UN Regulation No. 34 (Prevention of fire risk)

Revised proposal for 04 Series of Amendments to UN Regulation No. 34

Submitted by the expert from the International Organization of Motor Vehicle Manufacturers *

Model B (vacant)

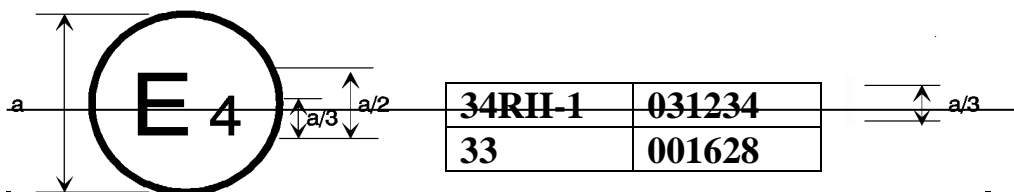
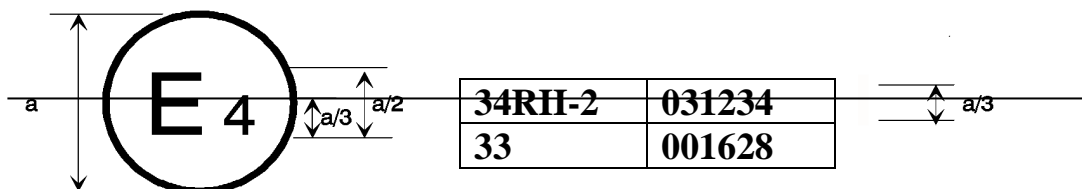
The above approval mark affixed to a vehicle shows that the type concerned was approved in the Netherlands (E 4) pursuant to Regulations Nos. 34 Parts I or IV and II-1 and 33.* The approval numbers indicated that, at the date when the respective approvals were given, Regulation No. 34 included the 0304 series of amendments and Regulation No. 33 was still in its original form.

The above approval mark affixed to a vehicle shows that the type concerned was approved in the Netherlands (E 4) pursuant to Regulations Nos. 34 Parts I or IV and II-2 and 33.* The approval numbers indicated that, at the date when the respective approvals were given, Regulation No. 34 included the 03 series of amendments and Regulation No. 33 was still in its original form."
